SERVICE BULLETIN

SUBJECT: Recommended Replacement of AEL12892 Thrust Buttons

PURPOSE: To notify customers of a potential incorrect material

Figure 1.

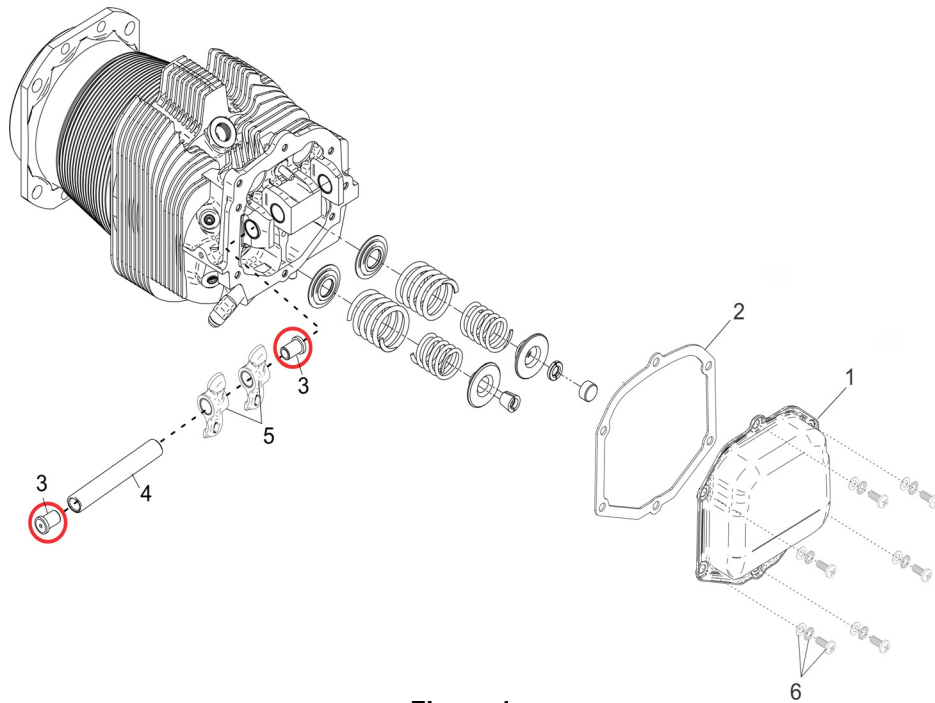
1. Disconnect power to engine.
2. Make sure engine is cool.
3. Remove the rocker cover (Figure 1) (1) and gasket (2) from the cylinder assembly. Discard the gasket (2).

If signs of overheating or accelerated wear of the thrust button (3) are found, ensure that no debris is present in the cylinder drain back line, oil sump, or in the rocker box area and contact Continental. If none are found, proceed to step 4.

4. Remove the thrust buttons (3). Removal of the shaft (4) and rockers (5) is not required.
5. Replace both thrust buttons (3) regardless of condition.

6. Install the rocker cover (1) with a new gasket (2) on the cylinder assembly.
7. Install and torque hardware (6) to the value specified in the engine's primary Instructions for Continued Airworthiness (ICA).
8. Enable power to the engine.
9. Complete the "Operational Ground Check" per the engine's primary ICA.
10. Make an appropriate engine logbook entry to document compliance with SB26-03.

Figure 2.

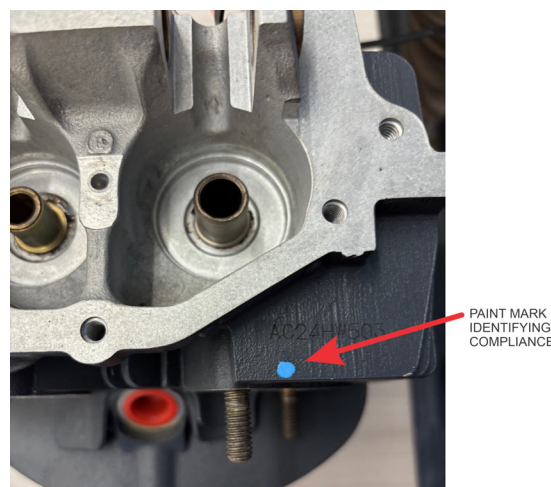
Continental has verified the material on some cylinders at our distributor's facility. The paint mark shown in Figure 2 identifies compliance. If this mark is on the cylinder, no further action is required.
